ADDENDUM 04

Issued: April 24, 2024

RE: Boney Courthouse Generator Replacement, ANC-C-2024-0005

BASEMENT
CORRIDOR
1ST FLOOR HVAC
REMODEL

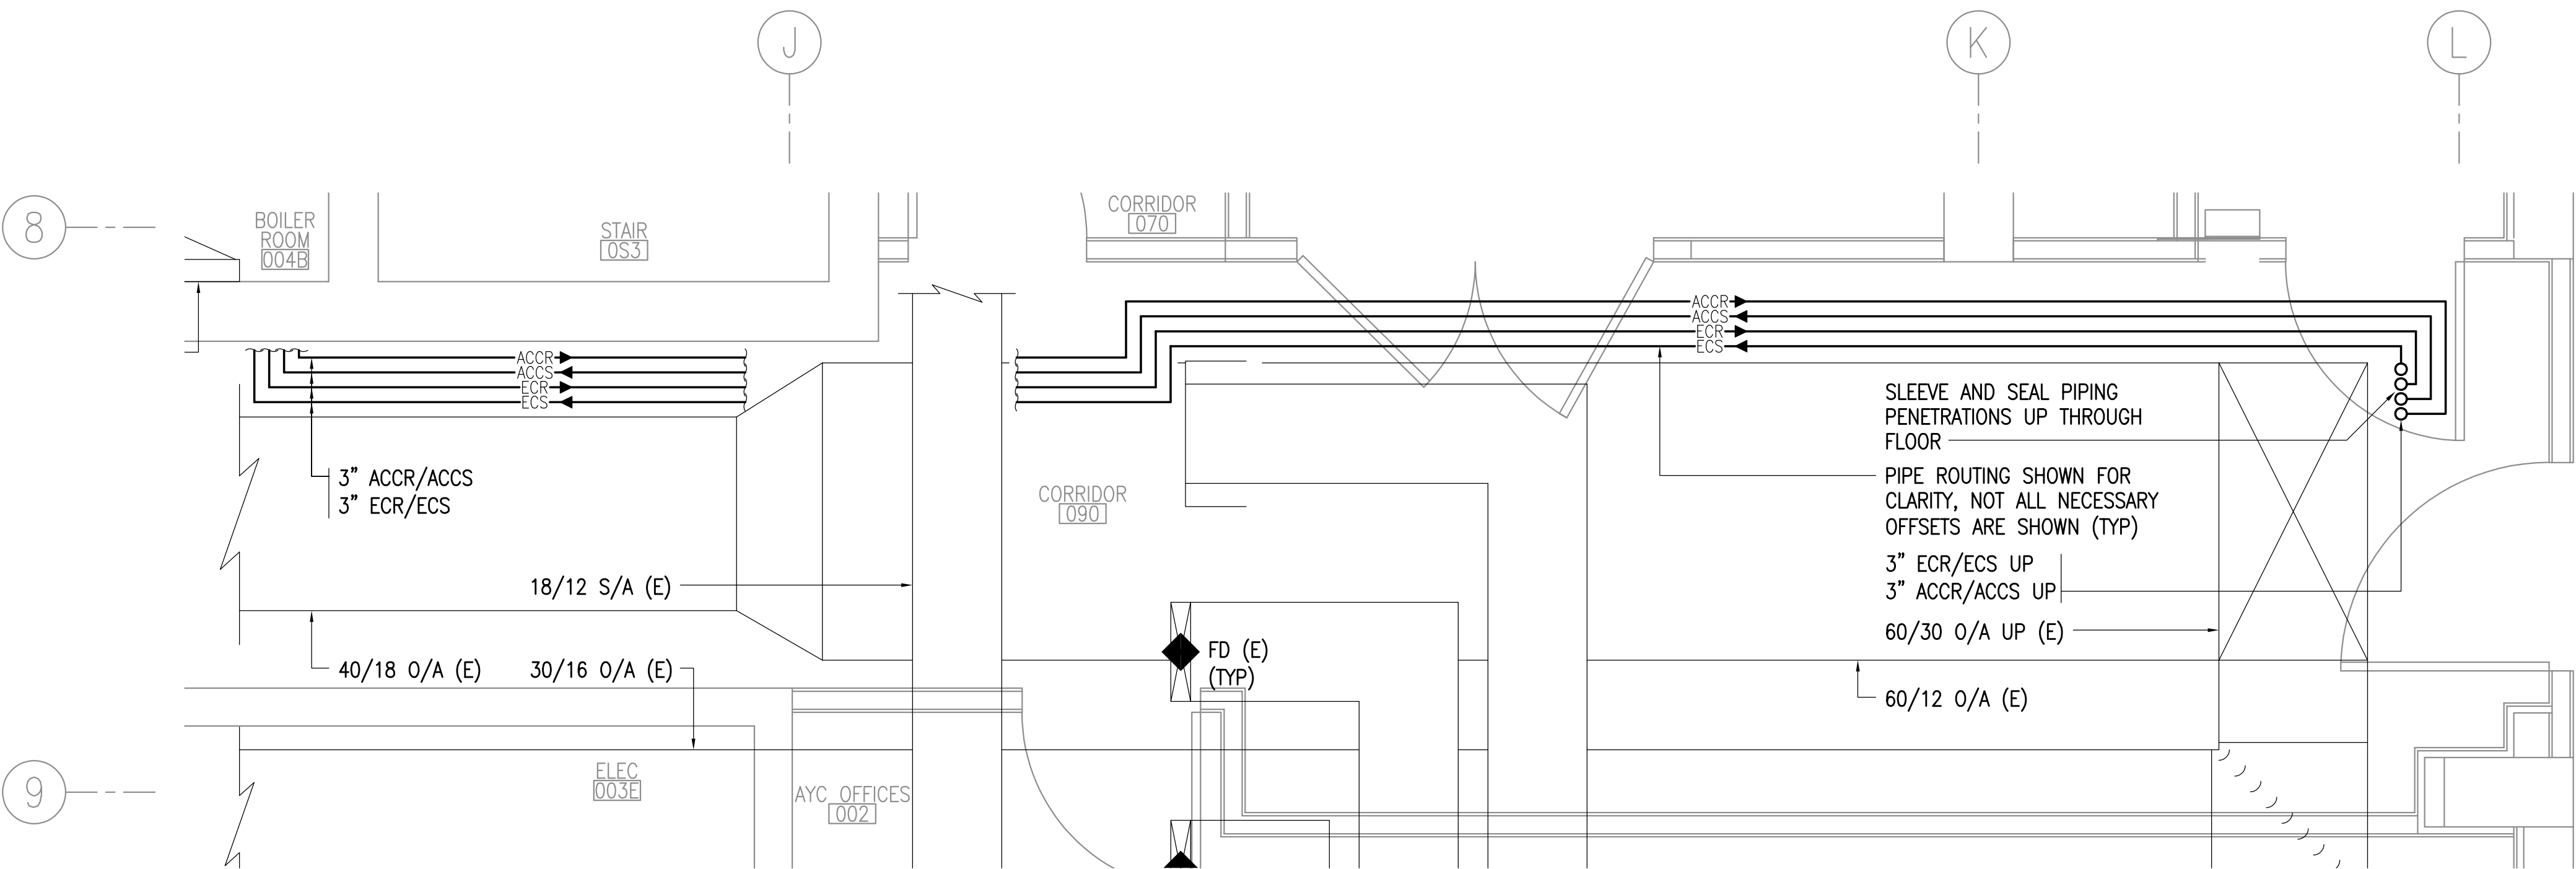
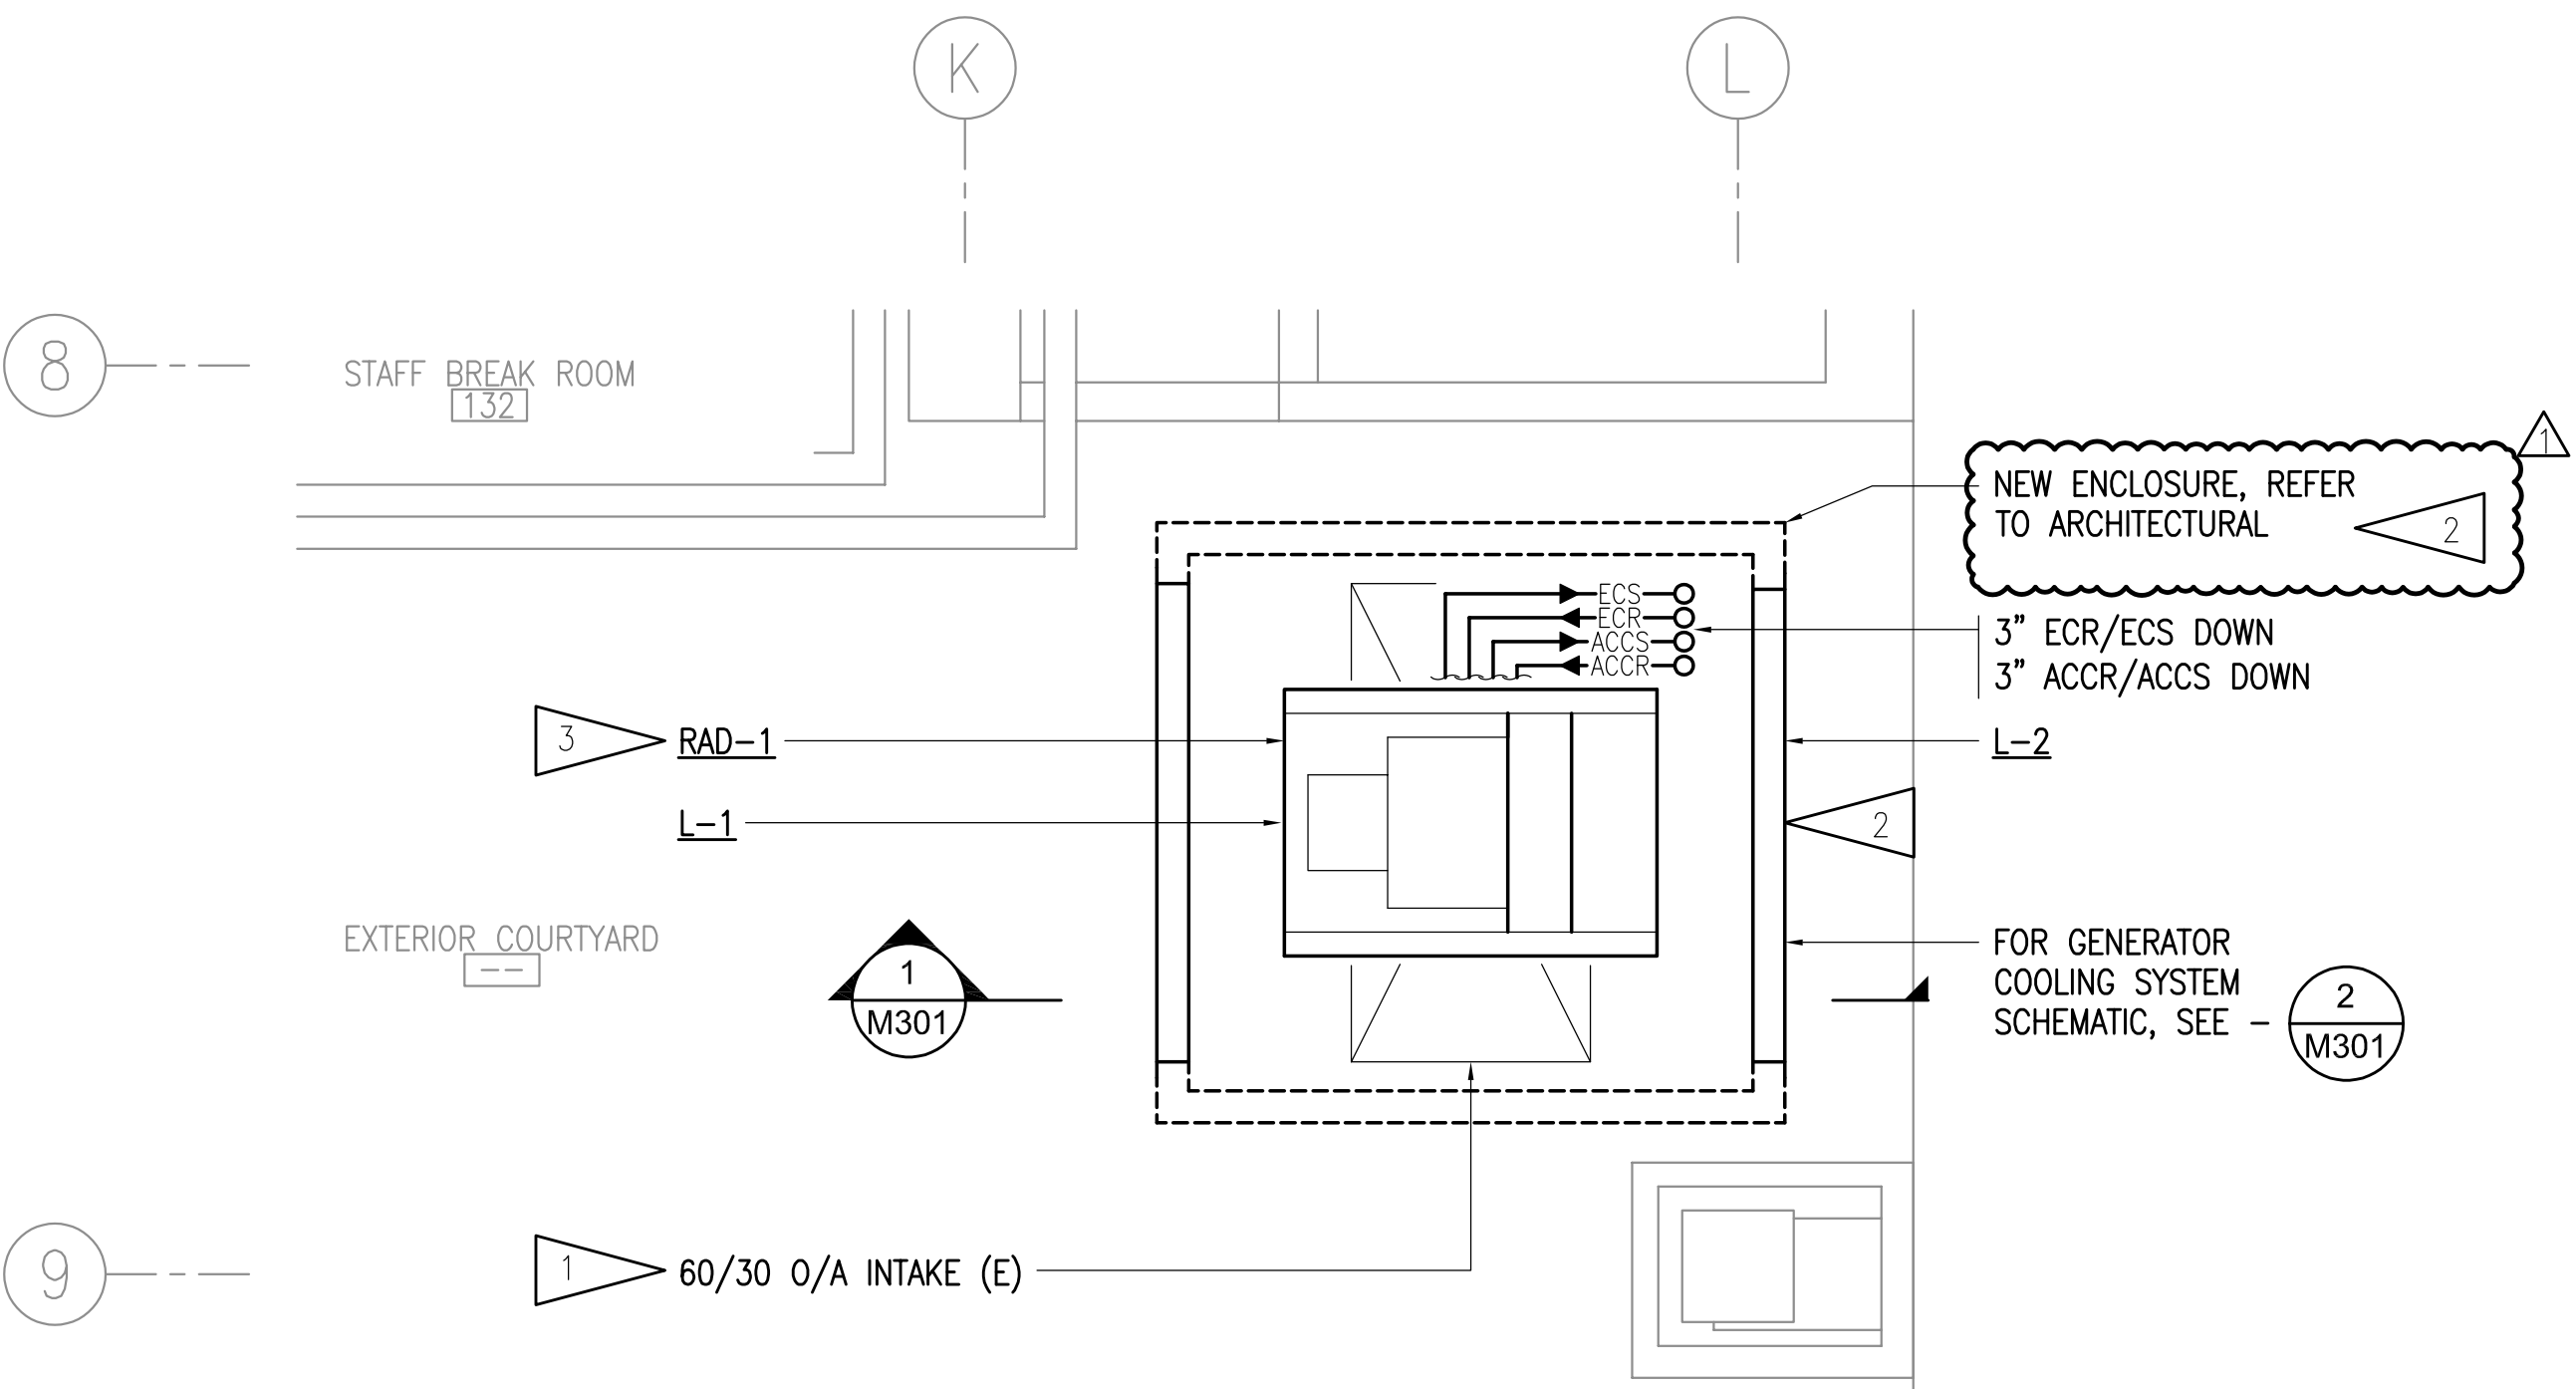
Sheet M202 is REVISED per attached.

10. Question: *The ceiling space outside the mechanical room where the 3" ECS/ECR and ACCS/ACCR piping is to run is extremely congested. Measurements were taken and there is only 12" of space +/- between the top of grid to the bottom of the supply duct running east west. The supply duct is tight to the bottom of structure. The entire run has conduit and sprinkler crossing the ceiling space north and south. These sprinkler lines and conduits are centered between the duct and grid.*

12. Question: *Detail 1/M202 shows (2) 3" ACCR/ACCS and (2) 3" ECR/ECS piping penetrations noting "sleeve and seal piping penetrations up through floor." Our understanding is that these (4) penetrations are to be new/added as part of this project, and will be penetrating the existing structural concrete ceiling comprised of a concrete waffle slab plus an unknown concrete thickness above on the exterior of the building. Please provide a structural penetration detail to account for this specific condition to include, but not be limited to, the total anticipated length of each core (thickness of total structural concrete build-up), the required spacing of each core, the total core diameter sized to accommodate the piping plus the required sleeve and insulation, and any requirements associated with X-raying the concrete given that cutting through structural rebar is a strong likelihood given the structural nature of the tunnel's roof/ceiling.*

Response: Alternate routes through adjacent rooms in the hallways were investigated but the corridor appeared to be the best option at the time. We would be open to alternative routing if proposed by the Contractor.
